**TOWN OF NEWBURGH
PLANNING BOARD
TECHNICAL REVIEW COMMENTS**

PROJECT NAME: AFONSO
PROJECT NO.: 22-11
PROJECT LOCATION: 14 MARINO DRIVE
SECTION 2, BLOCK 1, LOT 16 & 23.2
REVIEW DATE: 29 JULY 2022
MEETING DATE: 4 AUGUST 2022
PROJECT REPRESENTATIVE: DOCE ASSOCIATES

RE: Two Lot Subdivision and Lot Line Change Plan
Lands of Afonso - Marino Drive
Section 2 Block 1 Lots 16 and 23.2
Application No. 22-11

SHEET 1 OF 3

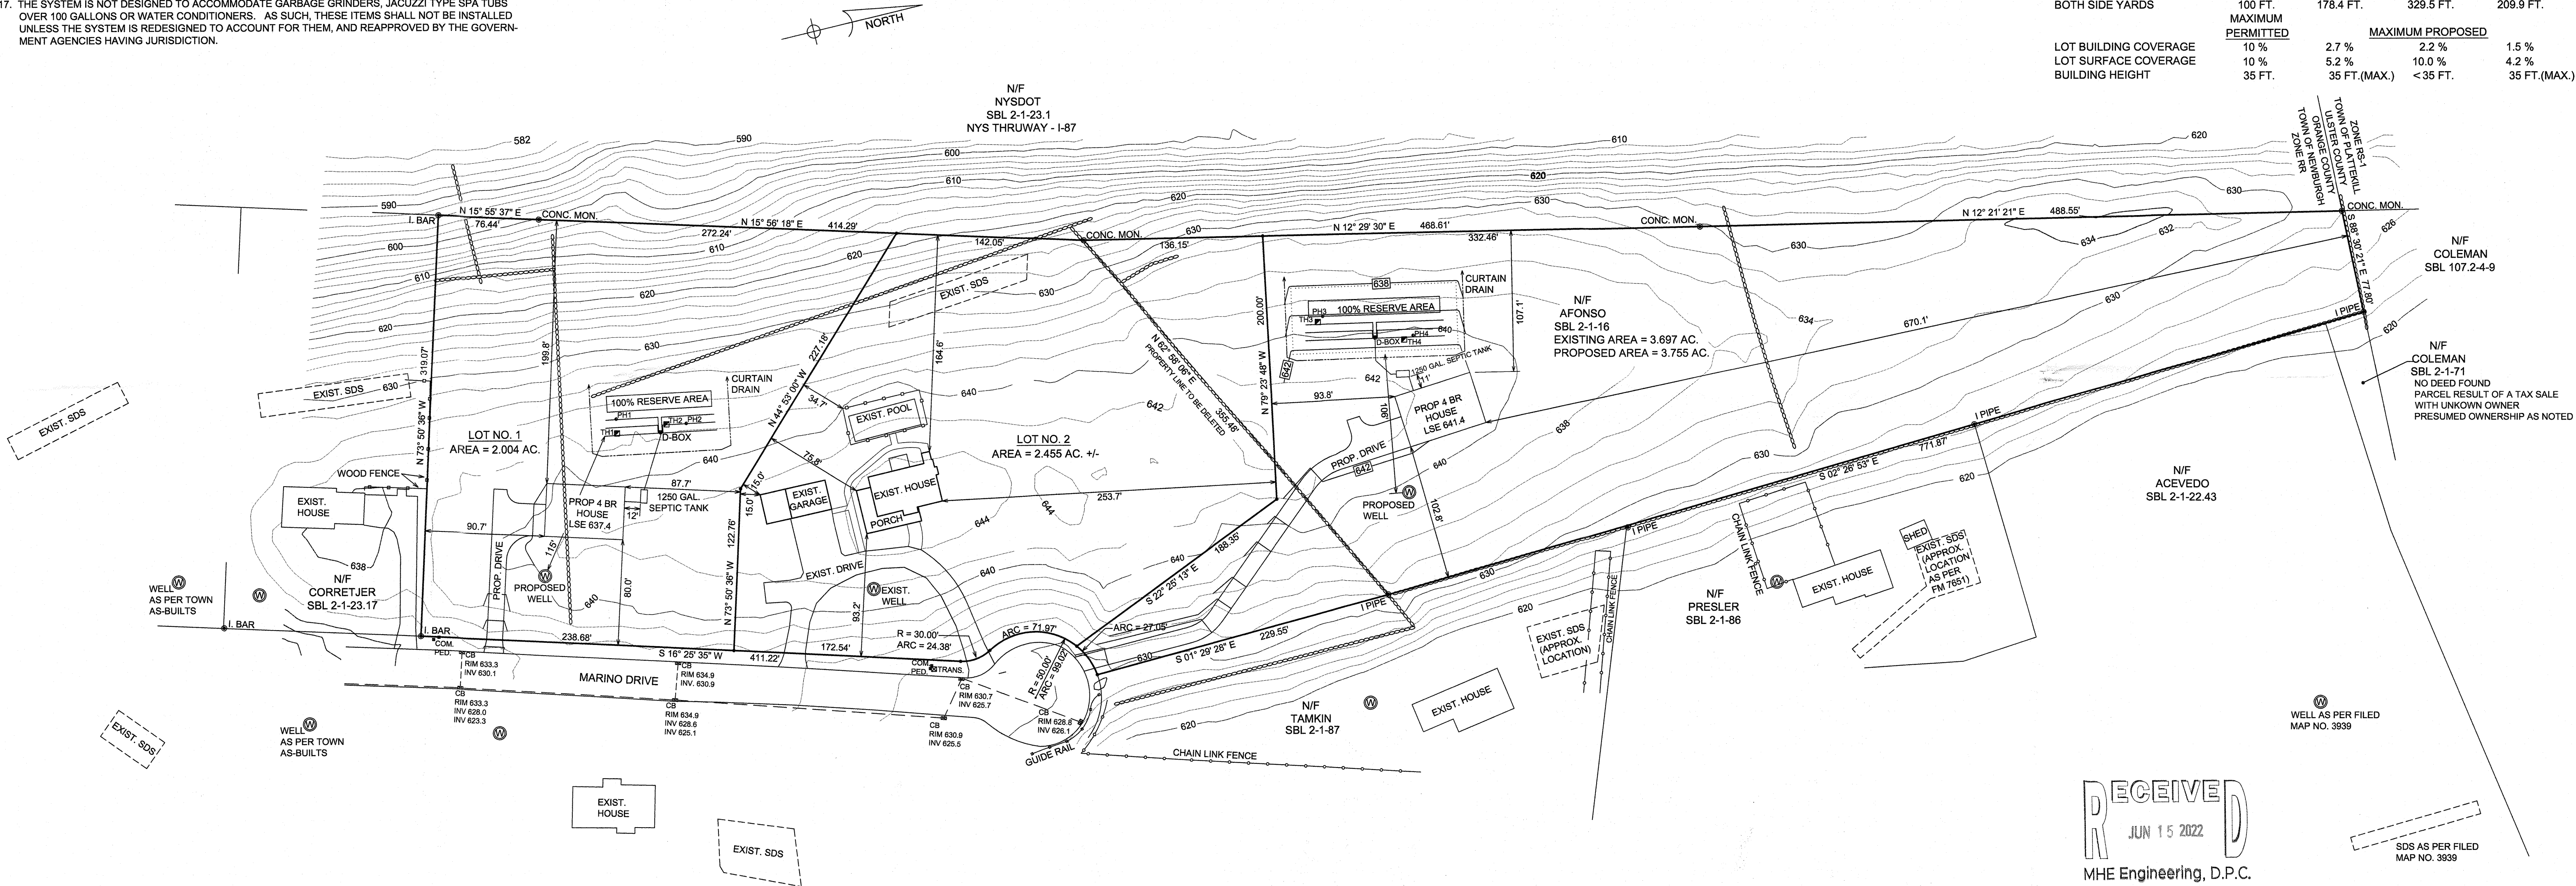
1. By letter dated June 6, 2022, the Orange County Department of Planning has reviewed the plan and has no advisory comments.
2. The bulk table (sheet 1) has been revised to remove the +/- references.
3. Tax Lot 87 does not have a driveway off of the Marino Drive cul-de-sac. Access to this lot is from Coventry Lane.
4. By a memo dated May 24, 2022, Mark Hall has indicated he has reviewed the plans and has no comment.
5. The bulk requirement setbacks have been labelled on each lot.
6. The chart for the proposed sewage system designs is located on sheet 1.
7. The adjoiner mailings were sent out May 31, 2022.

ZONE : RR REGULATION	MINIMUM REQUIRED	MINIMUM PROPOSED		
		LOT NO. 1	LOT NO. 2	SBL: 2-1-16
LOT AREA	2.00 AC.	2.004 AC.	2.455 AC.	3.755 AC.
LOT WIDTH	200 FT.	238.7 FT.	356.9 FT.	272.6 FT.
LOT DEPTH	300 FT.	320.1 FT.	322.2 FT.	832.1 FT.
FRONT YARD	60 FT.	80.0 FT.	93.2 FT.	93.8 FT.
REAR YARD	100 FT.	199.8 FT.	164.6 FT.	670.1 FT.
ONE SIDE YARD	50 FT.	87.7 FT.	75.8 FT.	102.8 FT.
BOTH SIDE YARDS	100 FT.	178.4 FT.	329.5 FT.	209.9 FT.
MAXIMUM PERMITTED				
LOT BUILDING COVERAGE	10 %	2.7 %	2.2 %	1.5 %
LOT SURFACE COVERAGE	10 %	5.2 %	10.0 %	4.2 %
BUILDING HEIGHT	35 FT.	35 FT.(MAX.)	<35 FT.	35 FT.(MAX.)
